# Safety Alert 024

## Title: Baxi & Potterton Heat Only - Condensate Trap

Date issued: 16 August 2017

**Figure 1 Original Retaining Clip & Lugs**

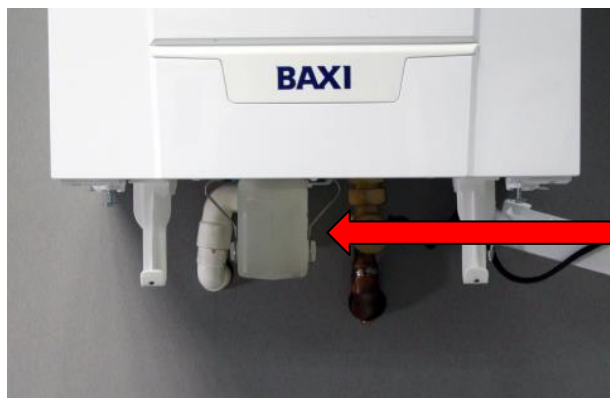
This has the potential to subject the condensate trap retaining clip to undue strain or deformation and could result in the retaining clip not being positively engaged on the condensate trap 'lugs' provided (**Figure 1**). Whilst the probability of this combination of factors occurring is very low, Baxi considers that it is important to share this information in order to ensure optimum safety.

Baxi have decided to modify the condensate trap retaining clip to minimise the risks associated with the removal and refitting of the retaining clip not being carried out in accordance with the manufacturer's instructions. This change was made from week 24 of 2017 as part of Baxi's ongoing commitment to continuous improvement and ensuring that the highest possible safety and reliability standards continue to be met.

If it is the original type (**Figure 1**) follow the 'Actions' listed on page 3. Baxi recommends that all condensate retaining clips of the original type (**Figure 1**) are exchanged irrespective of their current condition.

- 1) If the boiler has modification level **AC** or **BC** and the condensate trap retaining clip is the original type (**Figure 1**) a new condensate trap retaining clip assembly should be fitted. If a replacement clip assembly is not available during the inspection, the original trap and retaining clip should be checked to ensure it is fitted in accordance with manufacturer's instructions and, a free of charge\* replacement retaining clip assembly should be obtained as detailed on page 4 and fitted as a replacement at your earliest convenience.
